Botley West Solar Farm – Application for an Order granting Development Consent

Cassington Parish Council Response to the “late response from the Applicant to the request for further information (“RFI”) letter dated 14 April 2026 (re-issued 20 April and 28 April)”.

Figure 1. Proposed scaling back of the Botley West proposed solar arrays north of Cassington and Worton. Areas in red hatch are where solar arrays from the proposal are removed.

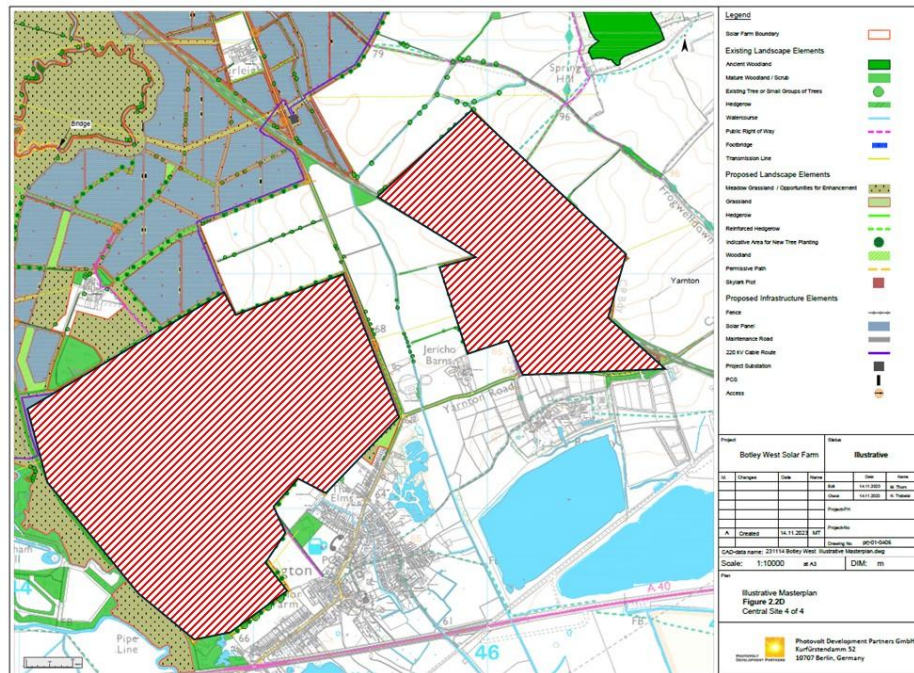
Cassington Parish Council are therefore proposing that either the Botley West proposal is rejected which remains both the Parish Council's and resident's favoured option, or it is scaled back from the north of the village to the summit of the hill contours that lie to the north of the village. A rough sketch of what this would look like is indicated in Figure 1 below.

This proposal has the advantage of moving the entire scheme back from Cassington village where we believe that it is far too close to dwellings in the village. This will help to preserve amenity of at least some of the public rights of way from Cassington and Worton. It also avoids issues around the potential alterations to local temperature that may occur as a result of conversion of solar energy to heat by the vast array of panels across the landscape. It also preserves some of the greenbelt and farmland that would otherwise be lost.
